**WEST SHORE LAKE PONTCHARTRAIN
HURRICANE AND STORM DAMAGE RISK REDUCTION STUDY
FINAL INTEGRATED FEASIBILITY REPORT
AND
ENVIRONMENTAL IMPACT STATEMENT**

**VALUE ENGINEERING
APPENDIX G**

VALUE ENGINEERING REPORT:

CEMVN-VE-14-02

AMITE RIVER DIVERSION CANAL MODIFICATION PROJECT AREA MAP

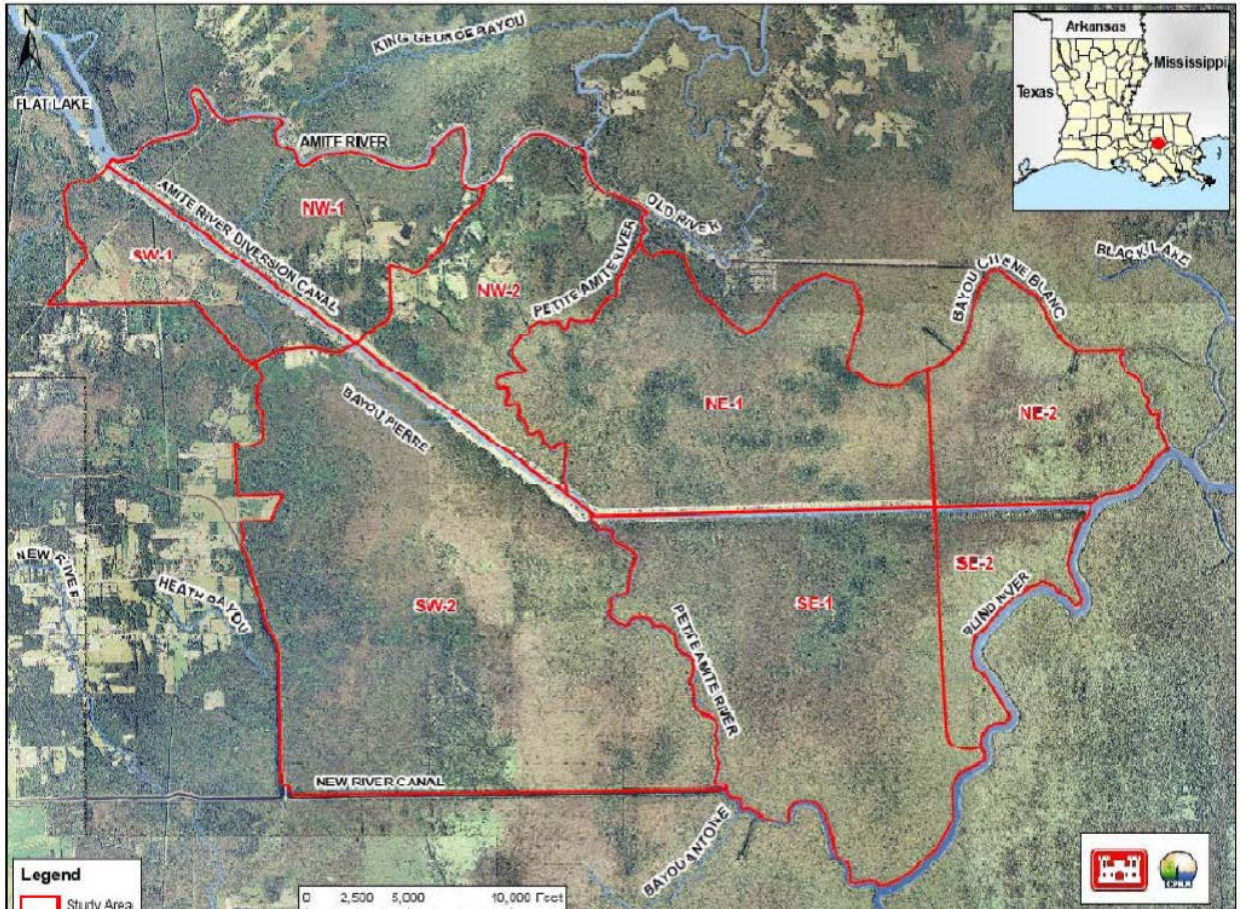
Item 1 – Consider non-implemented features of the Amite River Diversion Canal Modification Project for mitigation - A recent change in the LCA program indicates that the State no longer supports the lower basin project features of the item subject project (see below map). The potential benefit areas of these features are in close proximity to Westshore and could potentially be targeted as mitigation for the project and likely be far less costly than other measures. Amite River Diversion Canal Modification project features are described below.

Alternative Measures In Subunit NE-2

The measures currently being considered for Subunit NE-2 include the following:

Bank opening, north bank of Blind River, Location 1 (proposed by site reconnaissance team)

Channel dredging, pull boat trace, Location 2 (proposed by site reconnaissance team)

Bank opening, north bank of Amite River Diversion Canal, Location 3 (proposed as component of Measure BO14)

Bank opening, north bank of Amite River Diversion Canal, Location 5 (proposed by site reconnaissance team)

Bank opening, north bank of Amite River Diversion Canal, Location 6 (proposed as component of Measure BO14)

Two openings in railroad grade north of Amite River Diversion Canal, strategically located (proposed as component of Measure BO23)

Vegetative planting in degraded areas

Item 2 – Designate permanent conservation areas inside proposed levee alignment -

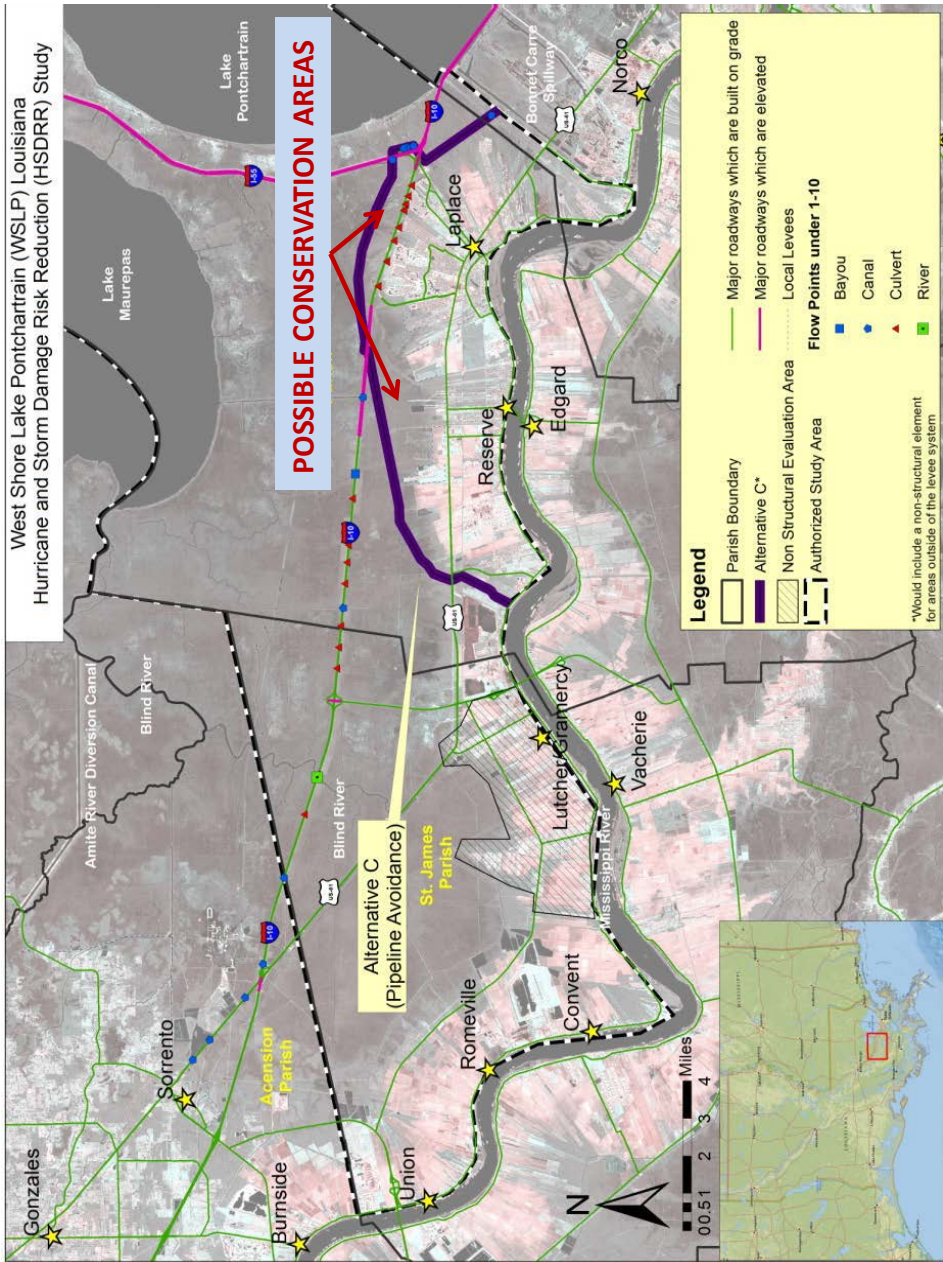
There appears to be the potential to reserve some of the areas that will be enclosed by the project. While the purchase of environmental easements may, or may not, be necessary, assuming future development of all enclosed areas and mitigating for some does not appear prudent since wetland development permits would not be granted. Two such possible areas are suggested and shown on the map below (additional areas should also be investigated). Water flow through drainage gates should be adequate to maintain hydrologic conditions. Also, there is the potential for future trails and other appropriate interaction features. Designating these reserve areas reduces indirect mitigation cost.

EXISTING CONDITIONS – POSSIBLE WATER ENTRAPMENT
(SCHEMATIC SECTION – NO SCALE)

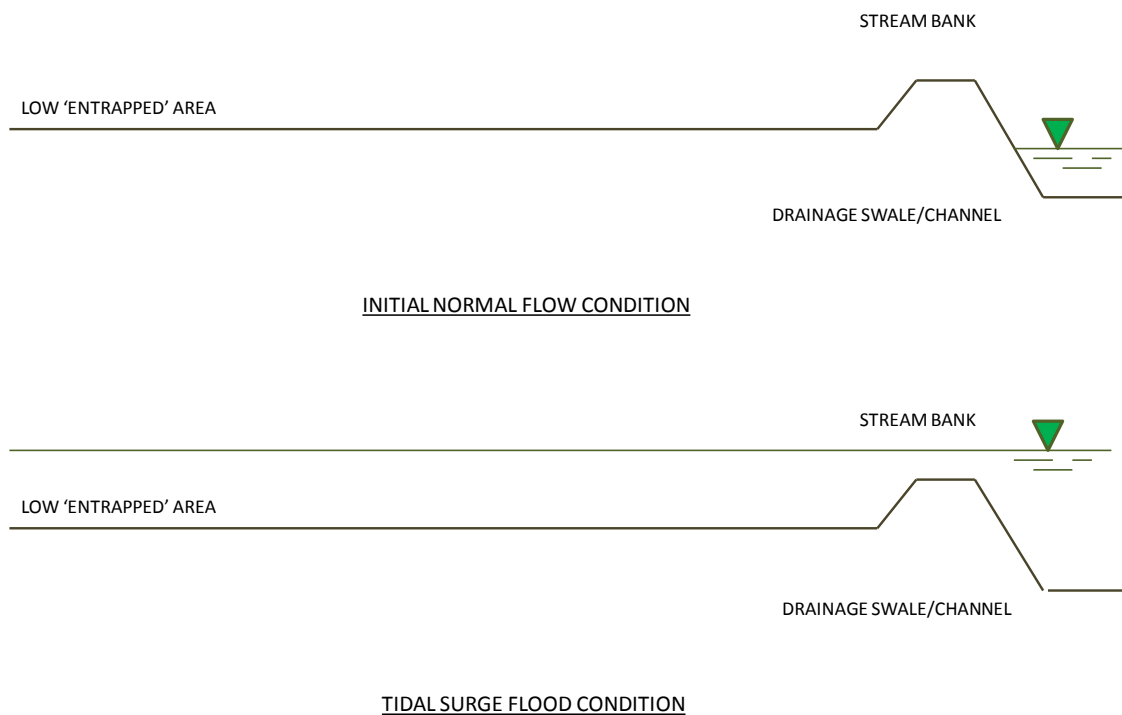
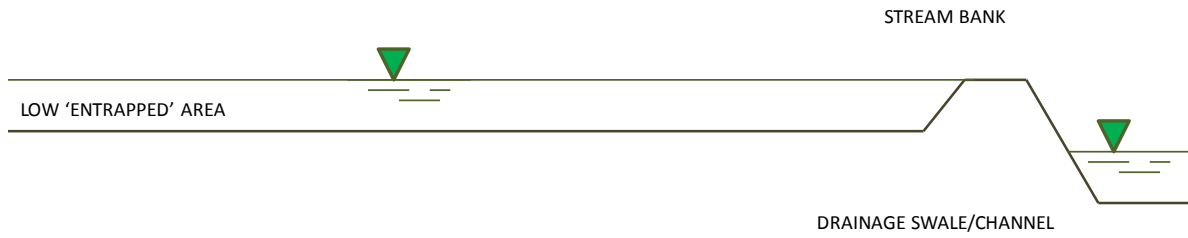
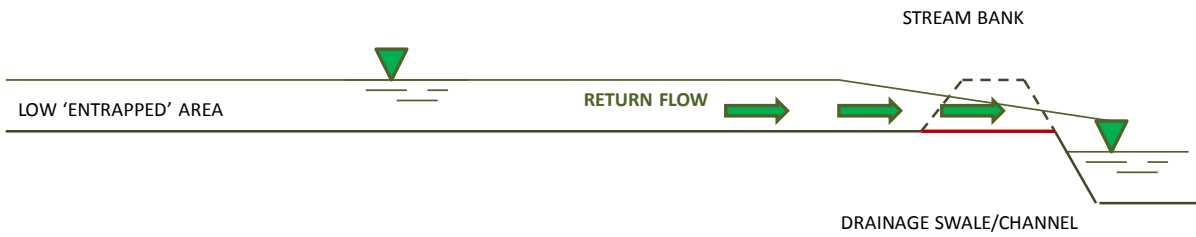
Item 3 – Consider internal water flow in mitigation feature design – Project mitigation areas will likely be located in area with hydrologic inflow and outflow. Investigation of existing local cypress swamps indicates the possibility of degradation due to flow entrapment. This is particularly evident in areas subject to tropical storm tidal flow events. It is therefore recommended that internal water flow modifications be considered for proposed mitigation areas. Such features mostly consist of berm excavation to connect apparent entrapment areas to drainage outlets as further described and depicted in schematics below.

(Description of Alternative Concept) Obtain further refined LiDAR and other data to identify ‘trapped’ low areas and/or possible unwanted collection points of freshwater diversion flow. Connect low areas to natural drainage outlets via strategically placed cuts in natural or man-made berms (such as canal spoil banks

Item 4 – Re-consider alignment to incorporate additional NER benefits - The current philosophy and assumptions regarding levee placement and environmental impacts of this project appear to be as follows:

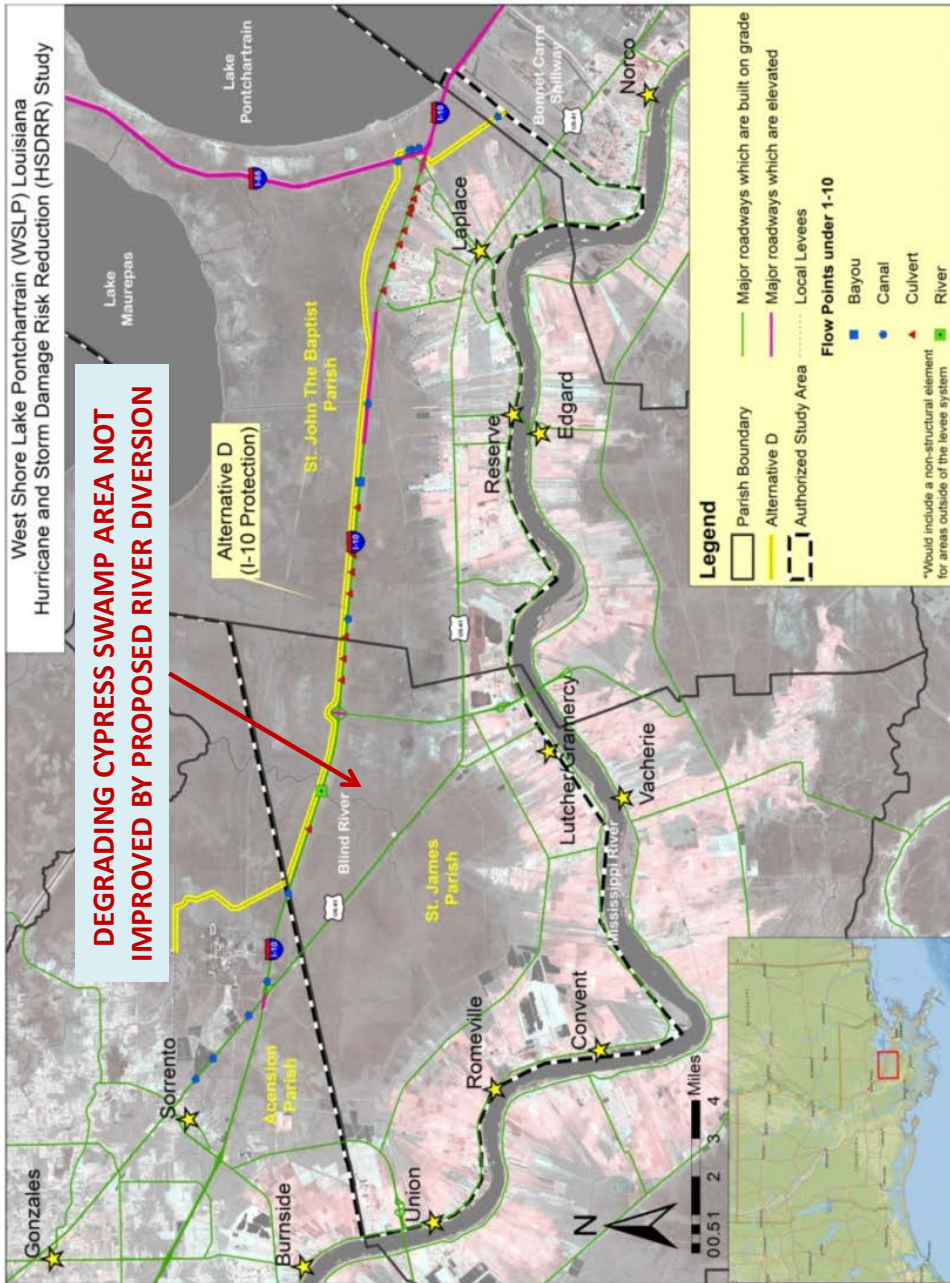
- Restricting open tidal flow, particularly sheet-flow, has negative impacts.
- It is assumed that all areas inside the levee system will be developed and eliminate habitat (indirect environmental impact).
- A key early assumption was that an adjacent proposed project – ‘*Convent/Blind River Diversion*’ would have positive effects on major cypress swamps from the Mississippi River northward beyond US Highway 61 (US61). See below map.

It is suggested that these above presumptions be re-visited with the following considerations:

- The current project design calls for gated drainage structures that will allow control of inflow and outflow to the interior; this ‘leaky levee’ concept is being embraced for the Morganza to the Gulf and other projects as environmentally sound. The control of saltwater intrusion, particularly when sea level rise is considered, may be a critical **positive** factor in maintaining area cypress swamps.

- It is possible to restrict development inside the levee system either by designating select areas as environmental reserves. This can be accomplished via purchase of an environmental easement (as required by CoE policy), by local ordinance or by simple designation since it appears very remote that a federal permit would ever be granted to develop these areas. While outright easement purchase may **(or may not)** be more expensive than mitigation, a waiver of CoE policy could be considered.

- Recent hydraulic analysis indicated the proposed Convent/Blind River Diversion Project will not have benefit to the part of the target area – that north of US61. As such, there is currently no proposed plan for protection of this significant cypress swamp area. Its primary degradation, apparently due in large part to saltwater intrusion and entrapment could be retarded with flow control such as a gated levee system could offer.

Given these reconsiderations, it may be determined that a westward extension of the proposed levee (similar to previous Alternative D) may actually produce net environmental benefits (NER) or at least not have nearly the negative impacts (and associated mitigation cost) as previously estimated. Without such an extension, continued loss of a vast area of significant cypress swamp will continue to degrade at its current rate of loss.
